## **Rouse Hill Hospital - H124498**

We have provided the responses to all submissions as requested in TTPM-GCOR-001365 on the Traffic Works for SSDA Design for the new Rouse Hill Hospital (Corner of Commercial Road and Windsor Road, Rouse Hill). These are detailed in table in Attachment A.

## Attachment 1: RtS Table

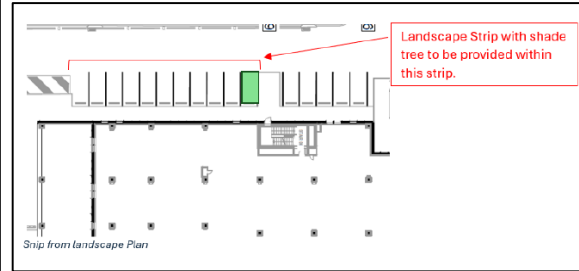
14 It appears that Truck bays 1, 4 & 5 cannot enter the loading dock if other heavy vehicles are parked in either dock 1 or dock 2. This may result in trucks waiting on the access road until such time as they can enter safely. It is also noted that trucks leaving the loading dock occupy the full road width when turning from the loading dock driveway into the access road.  
Recommendation: TfNSW recommends that the Applicant consider managing this via the Operational Plan of Management for the

Noted

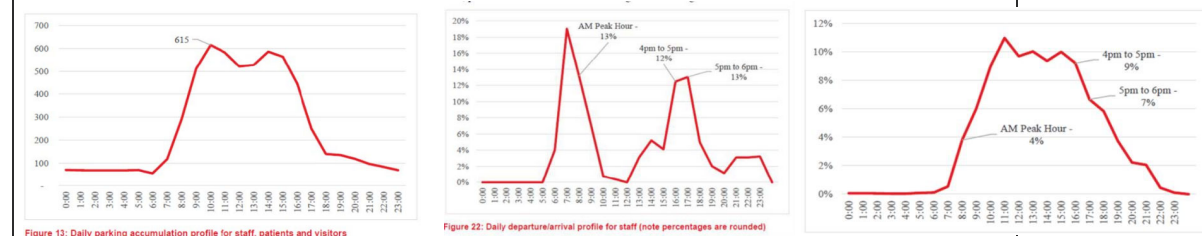
19 The trips have been revised compared to the initial study however the size of the development has increased from 15,000m<sup>2</sup> to 39,100 m<sup>2</sup> (excluding the proposed multi-storey car park of 13,750 m<sup>2</sup> GFA). This represents more than a twofold increase in GFA. However, the corresponding revised trips have not increased in proportion to the increase in development size as expected. The revised trips have a marginal  
The TAlA provides parking spaces and person/vehicle trips however it says the rates are based on the Schedule of Accommodation (SoA), other project-specific information from Health Infrastructure, and profile surveys of other Sydney hospitals. No evidence has been provided to  
The peak parking demand is derived from the peak point of a graph in the study however there is no evidence showing how the demand and peak period axes were determined.  
Similarly, the peak hour person and vehicle trips are also based on graphs produced by the applicant's traffic consultant with no supporting

Refer to response to Comment 2
